**MEMORANDUM**

REVIEW TYPE: **Site Plan Review**
 CASE #: **8-99024B**
 PROJECT NAME: Shady Grove Adventist Hospital
 APPLYING FOR: Approval of 5,892 s.f. of electrical room addition
 REVIEW BASIS: Div. 59-D-3 of Montgomery County Zoning Ordinance
 ZONE: Life Sciences Center (LSC)
 LOCATION: On Medical Center Drive, at the intersection with Medical Center Way
 MASTER PLAN: Shady Grove Master Plan
 APPLICANT: Shady Grove Adventist Hospital
 FILING DATE: May 26, 2005
 HEARING DATE: July 28, 2005

STAFF RECOMMENDATION: Approval of Site Plan Amendment 8-99024B for 5,892 s.f. electrical room addition to existing hospital on 39.16 acres. All site elements of the Shady Grove Adventist Hospital plans stamped by M-NCPPC on May 26, 2005 shall be required except as modified by the following conditions:

View from north of hospital showing northeast corner of Shady Grove Adventist Hospital and location of proposed electrical room addition.

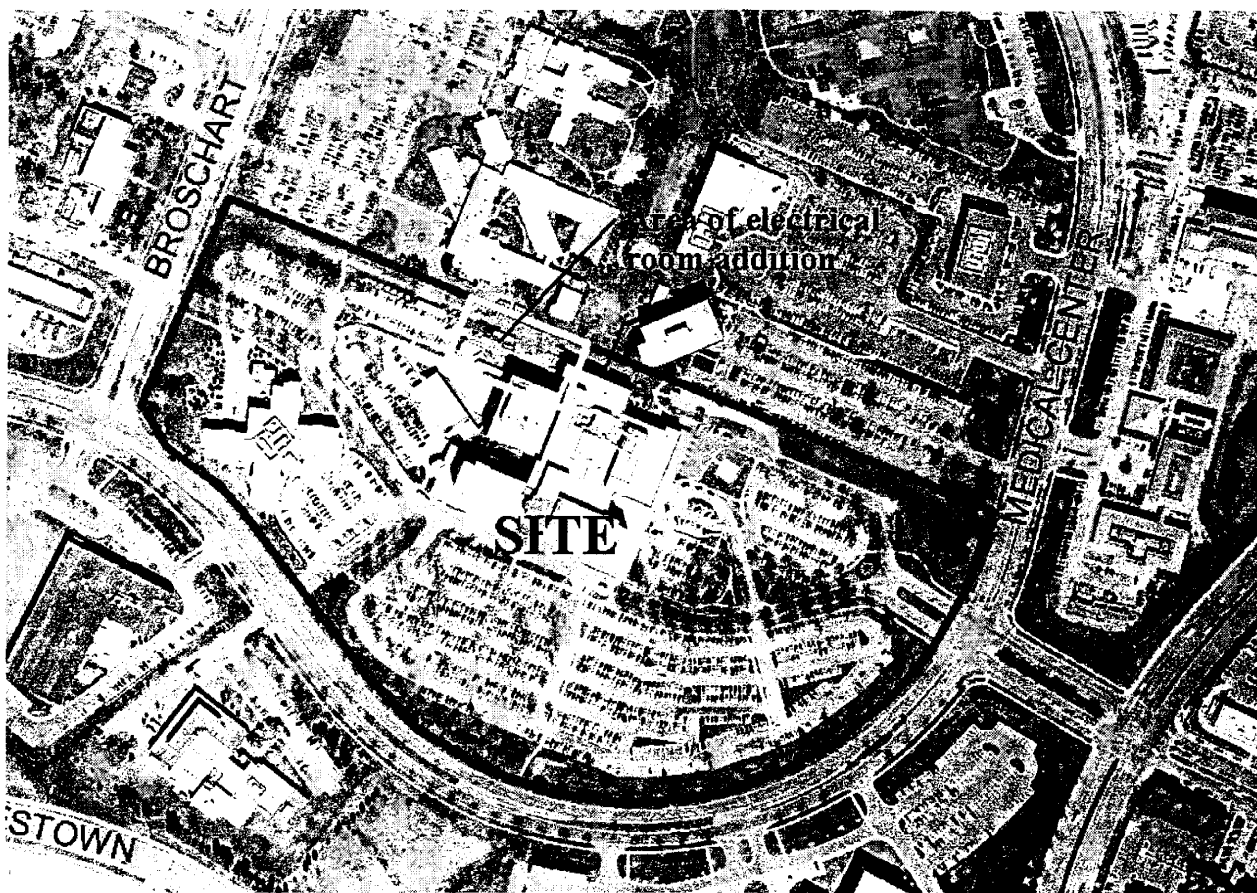
The site is currently approved for 408,931 square feet of hospital and rehabilitation hospital (FAR and non-FAR space) and 1,096 space parking spaces. The parking lot holds many mature trees in varying degrees of poor and good health that will be replaced or relocated. The building addition is located on the northwest corner of the main hospital between the main hospital and the Potomac Ridge Behavioral Health Center.
